# UNITED STATES PATENT AND TRADEMARK OFFICE

APPLICATION NO.	FILING DATE	FIRST NAMED INVENTOR	ATTORNEY DOCKET NO.	CONFIRMATION NO.
10/698,969	10/31/2003	Dimiter S. Zagoroff	3567.1001-000	8813

**Office Action Summary**

Application No.: 10/698,969  
Title: Method and Apparatus for Remote...  
Inventor: Dimitar S. Zagoroff  
Replacement Sheet

Fig. 6A

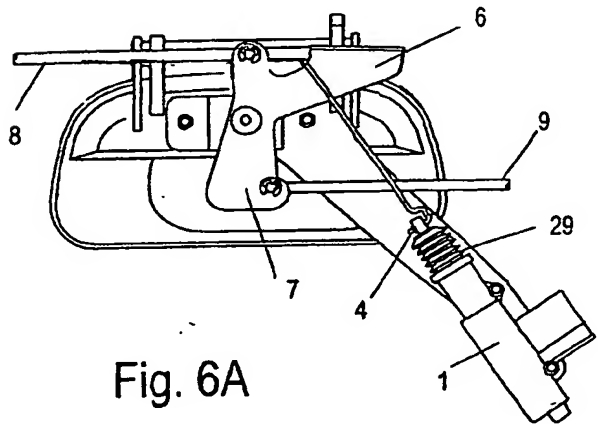
FIG. 6A  
approved  
D/S  
2/23/05
